DECISION ON DISTRICT PLAN CHANGE 18: ORIENTAL BAY HEIGHT AREA

**WELLINGTON CITY COUNCIL
REPORT OF THE HEARING COMMITTEE**

**SUBJECT: PROPOSED DISTRICT PLAN CHANGE 18:
ORIENTAL BAY HEIGHT AREA**

DISTRICT PLAN CHANGE 18 – ORIENTAL BAY HEIGHT AREA, IMPLEMENTATION OF DESIGN GUIDE FOR ORIENTAL PARADE, REVIEW OF MAXIMUM BUILDING HEIGHTS FOR 110-174 ORIENTAL PARADE, REVIEW OF DISCRETIONARY ACTIVITY FOR BUILDING HEIGHT.

District Plan Change 18, Chapter 5 - Residential Area Rules
Appendix 4 - Oriental Bay Height Area
Building Heights, 144-174 Oriental Parade

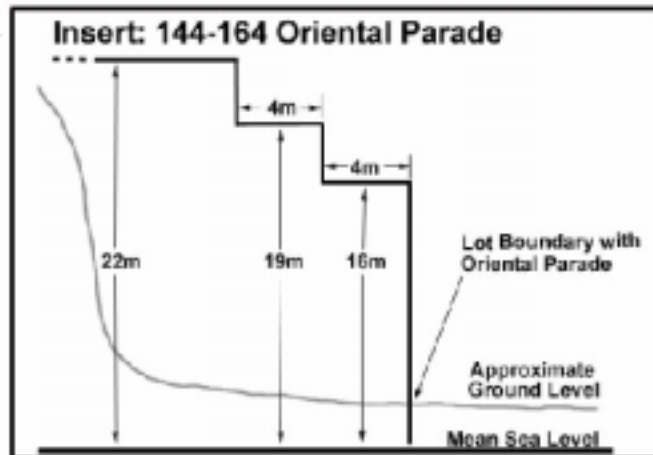
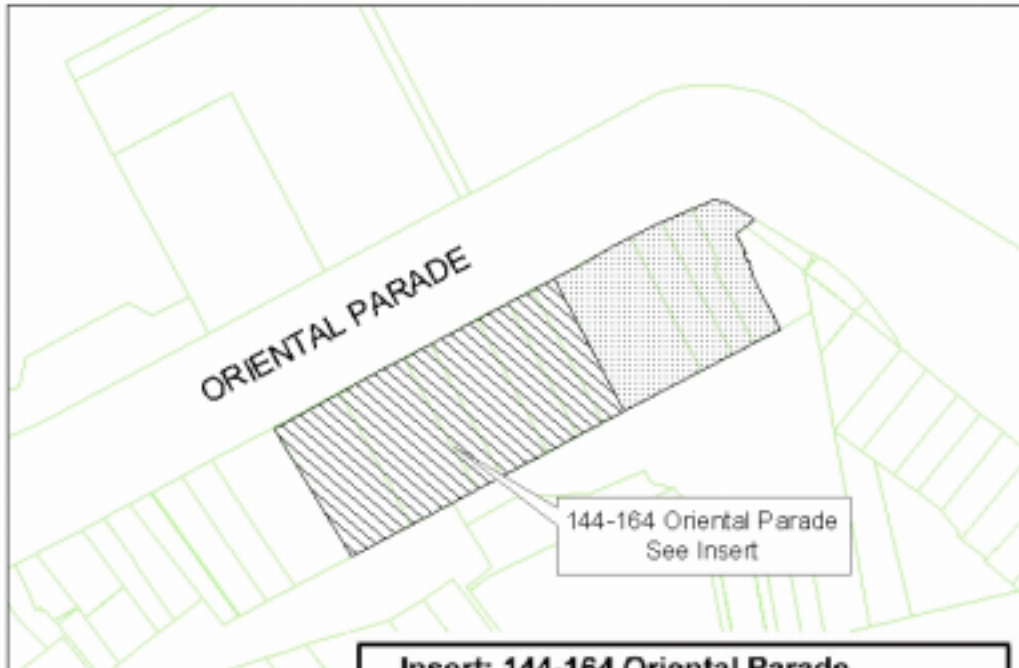
13. **Insert** the attached map titled "District Plan Change 18, Chapter 5 – Residential Area Rules. Appendix 4 – Oriental Bay Height Area. Building Heights, 144-174 Oriental Parade." after Appendix 4, Oriental Bay Height Area.

Make provision in the District Plan for permitted building heights up to 22 metres (above mean sea level) subject to setbacks from the street frontage for that portion of the building above 16 metres (above mean sea level), for properties between 144-164 Oriental Parade.
